CONTRACT CHANGE ORDER NO. ____
SHEET ____ OF ____

**ALTERNATE BARRIER DETAILS -
CONNECTION BEFORE LOAD TRANSFER**

**SAN FRANCISCO OAKLAND BAY BRIDGE
EAST SPAN SEISMIC SAFETY PROJECT
SELF-ANCHORED SUSPENSION BRIDGE
(SUPERSTRUCTURE & TOWER)
BARRIER DETAILS NO. 2C**

MARK	DATE	DESCRIPTIONS	BY	CH'D	CCO#
Δ	04/05/10	BARRIER MODIFICATIONS	GB	MN	44
		REVISIONS

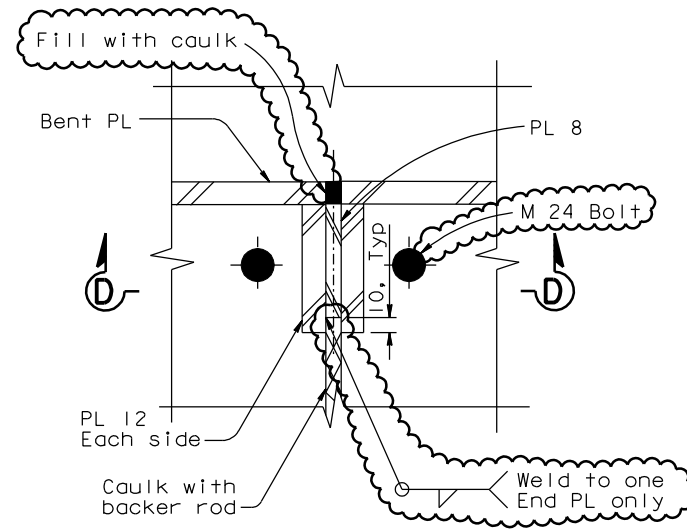
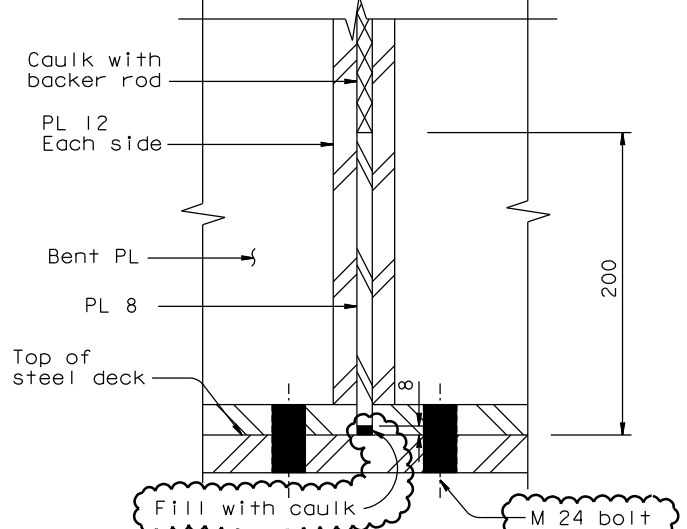
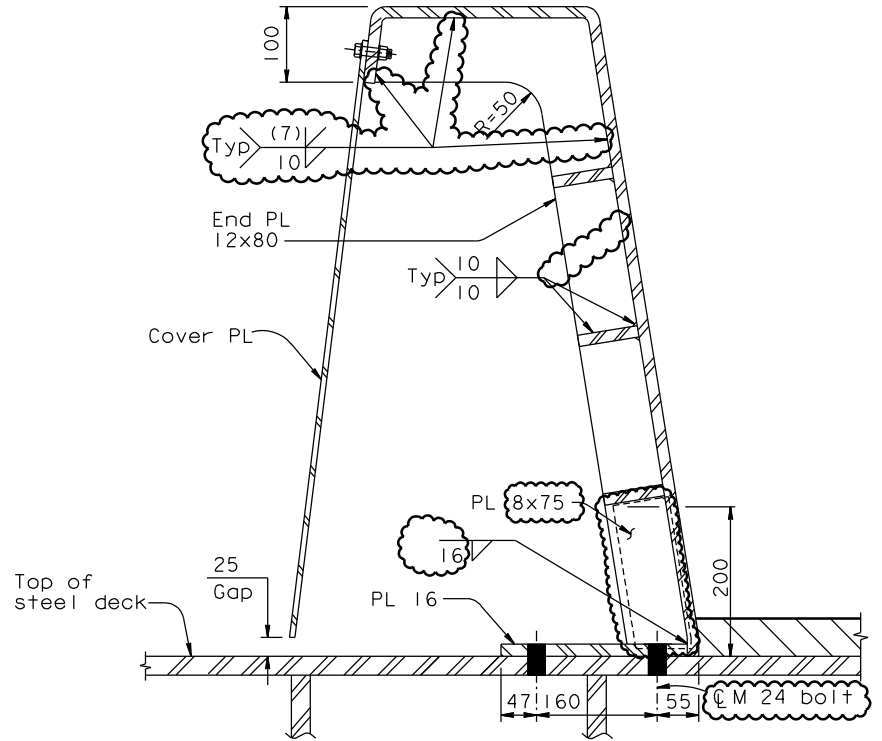
- Between PP 120+350 and PP 120+1250, the Contractor shall provide shim plates under the barrier base plates and under the barrier connections as required to fill the gap caused by the OBG kink. The 68 Dia drainage cut-out in the barrier diaphragm shall not be blocked, and the caulk shall be thickened under the barrier along the curb lines between these panel points.

- Bolt holes shall be standard size in the deck PL and oversize in the barrier.
 - All bolts between the barrier and the deck shall be tensioned prior to load transfer.

- For Section C-C and Details not shown for Lines W5/E2, see "Barrier Details No. 1".
 - Following installation of all HS bolts all anchor rods for barrier segment shall be installed snug tight. They shall then be tightened by an additional one-half turn of the nut.
